**SOLICITATION AMENDMENT  
MODIFICATION DE L'INVITATION**

<b>Title - Sujet</b> Sir Leonard Tilley Building Annex	
<b>Solicitation No. - N° de l'invitation</b> EJ078-182193/A	<b>Amendment No. - N° modif.</b> 004
<b>Client Reference No. - N° de référence du client</b> 20182193	<b>Date</b> 2018-03-26
<b>GETS Reference No. - N° de référence de SEAG</b> PW-\$\$\$FG-362-74521	
<b>File No. - N° de dossier</b> fg362.EJ078-182193	<b>CCC No./N° CCC - FMS No./N° VME</b>
<b>Solicitation Closes - L'invitation prend fin at - à 02:00 PM on - le 2018-04-10</b>	<b>Time Zone Fuseau horaire</b> Eastern Daylight Saving Time EDT
<b>F.O.B. - F.A.B.</b> <b>Plant-Usine:</b> <input type="checkbox"/> <b>Destination:</b> <input checked="" type="checkbox"/> <b>Other-Autre:</b> <input type="checkbox"/>	
<b>Address Enquiries to: - Adresser toutes questions à:</b> Kelly, Jessica	<b>Buyer Id - Id de l'acheteur</b> fg362
<b>Telephone No. - N° de téléphone</b> (873) - ( )	<b>FAX No. - N° de FAX</b> ( ) -

Amendment 004 is issued for the following:

drawing <b>MECHANICAL LEGEND</b> REF. DWG : M-001 REV.1

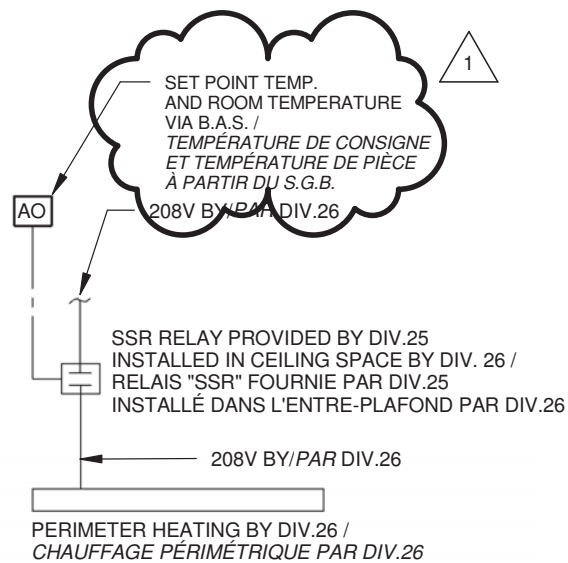
- 16 REMOVE FLOOR FINISH IN ALL AREAS AFFECTED BY NEW FLOORING MATERIAL.
- .8 M-001 Mechanical Legend, rev. 1 (Drawing modified, sketch SKT-01 issued)

- 1. Delete Fire Protection equipment legend entirely.  
Replace with: Fire Protection equipment legend as per attached sketch SKT-01.
- .9 M-400 – Mechanical – Ventilation New Layout, rev. 1 (Drawing modified, not issued)

SURFACE MOUNTED FIRE EXTINGUISHER (SEE SPECIFICATIONS FOR DESCRIPTION)  
EXTINCTEUR PORTATIF EN SURFACE (VOIR DESCRIPTION AU DEVIS)
